44 Park Avenue Conversion

Plan Views

A 1.1

1	PROPOSED FIRST FLOOR PLAN
¼"=1'-0"

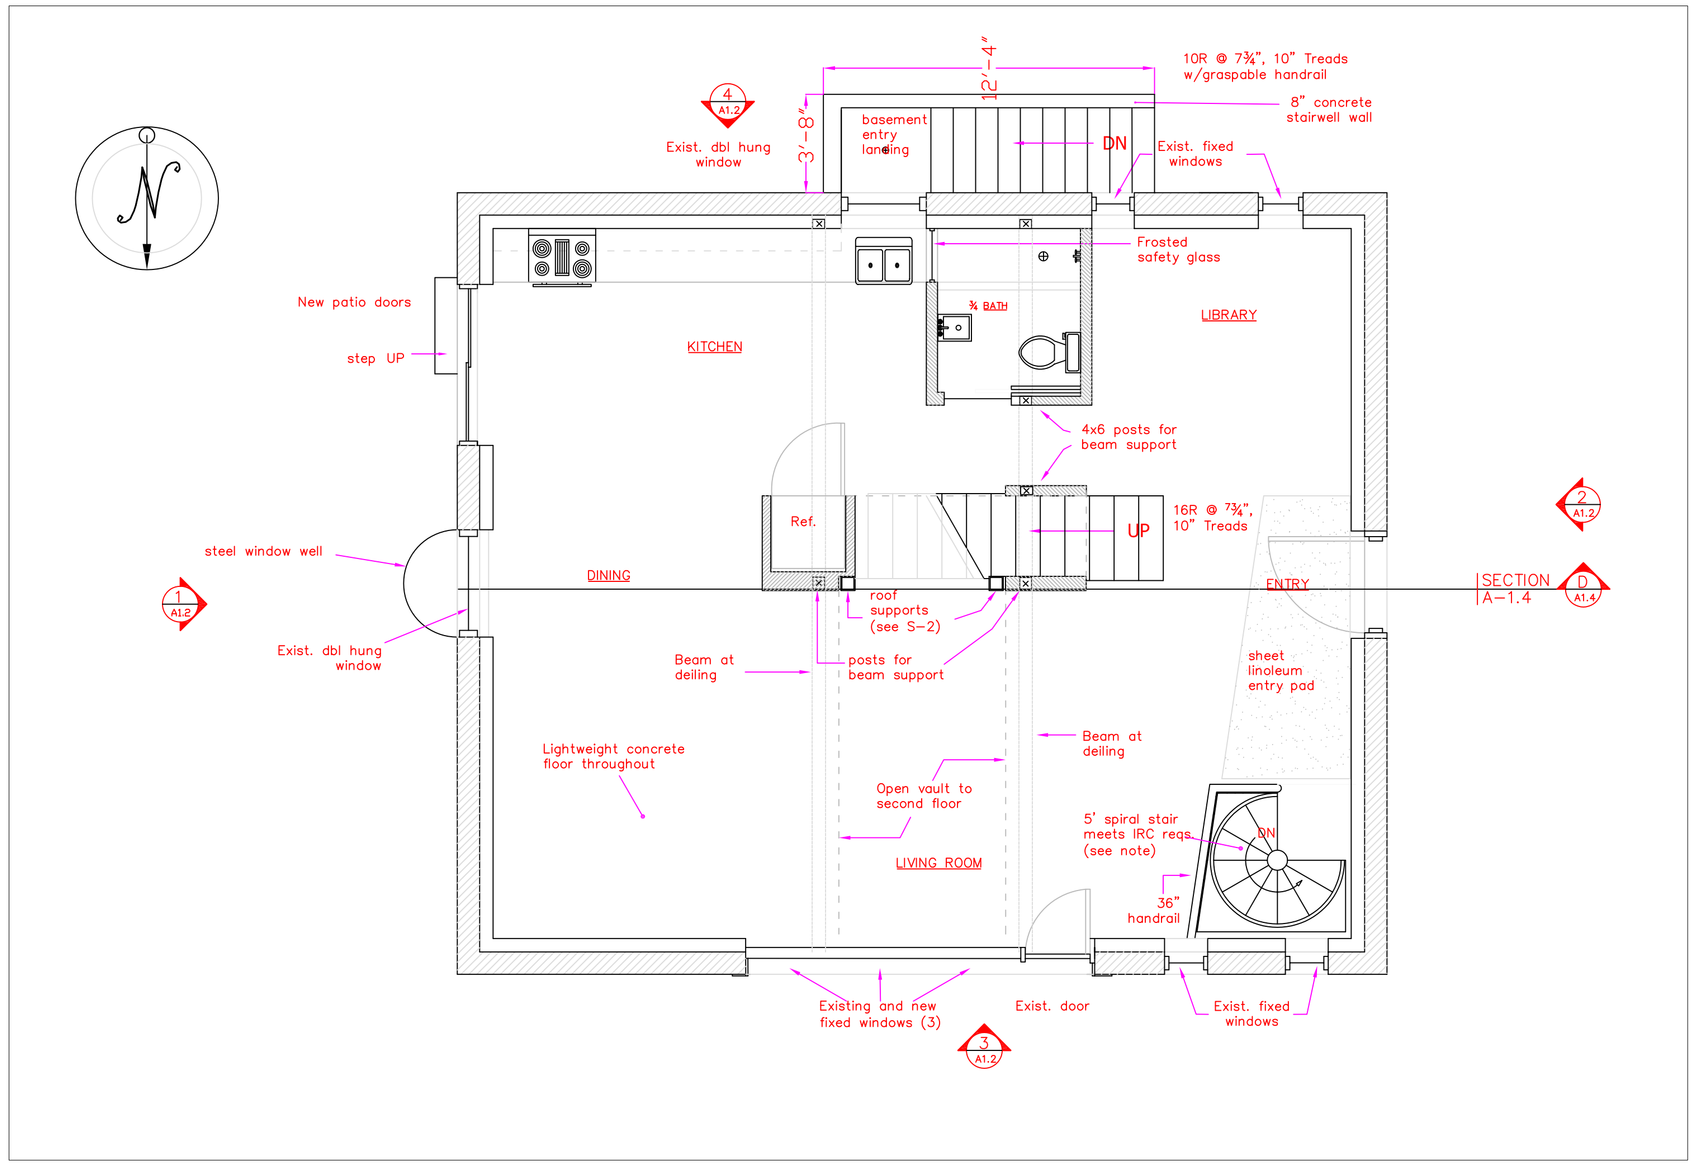
9.) Rev. 2: West floor 1 bathroom window removed.

2	PROPOSED SECOND FLOOR PLAN
¼"=1'-0"

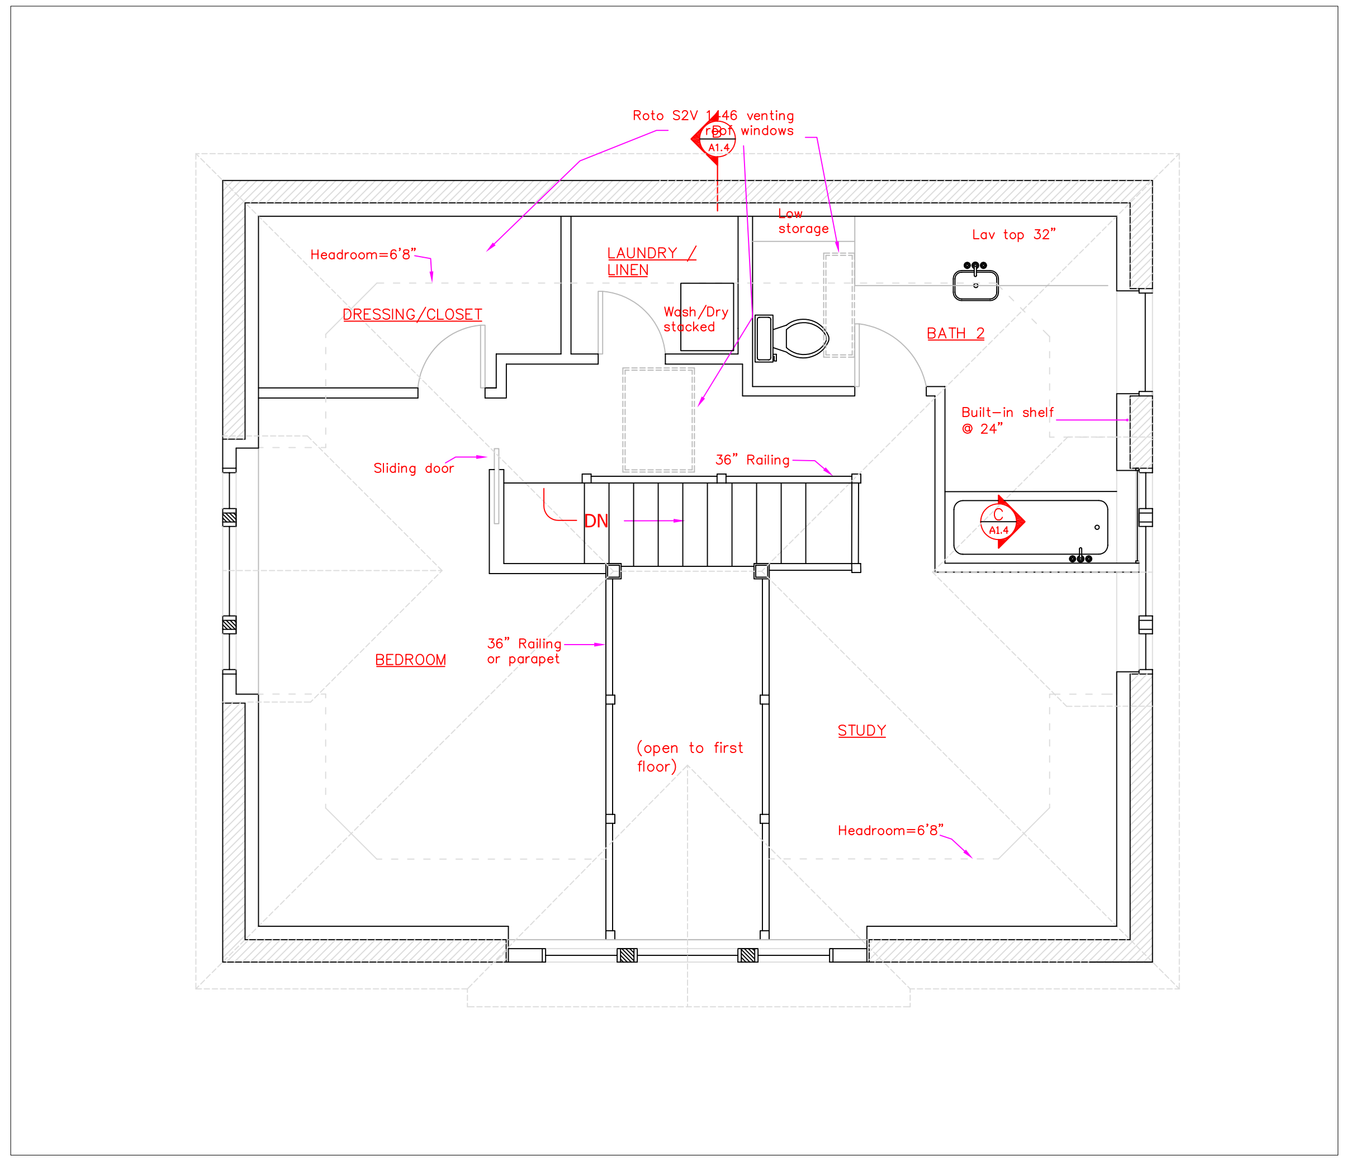
6.) Rev. 1: floor 2 bathroom sink moved to adjust for limited headroom under hip support.

7.) Rev. 1: chimney moved to pass through second floor.

4	PLOT PLAN
1/8"=1'-0"

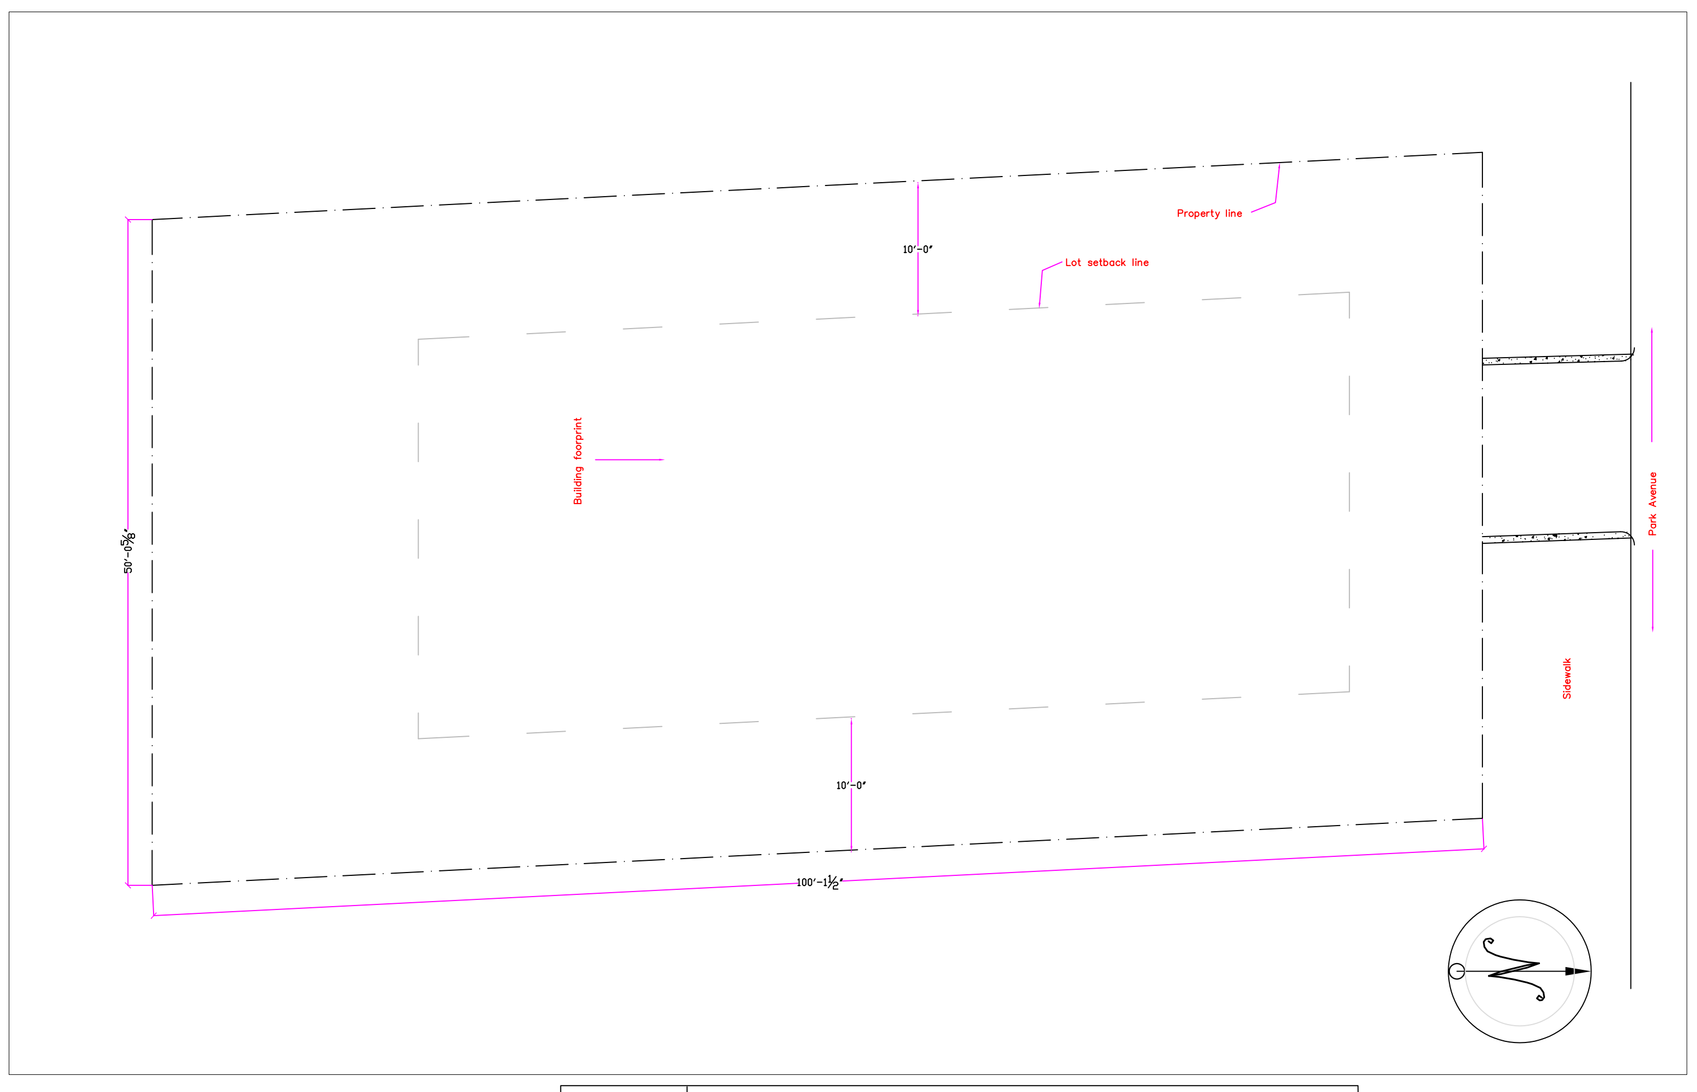
10.) Rev. 2: Ext. basement stair moved to south yard and window well added for east basement window.
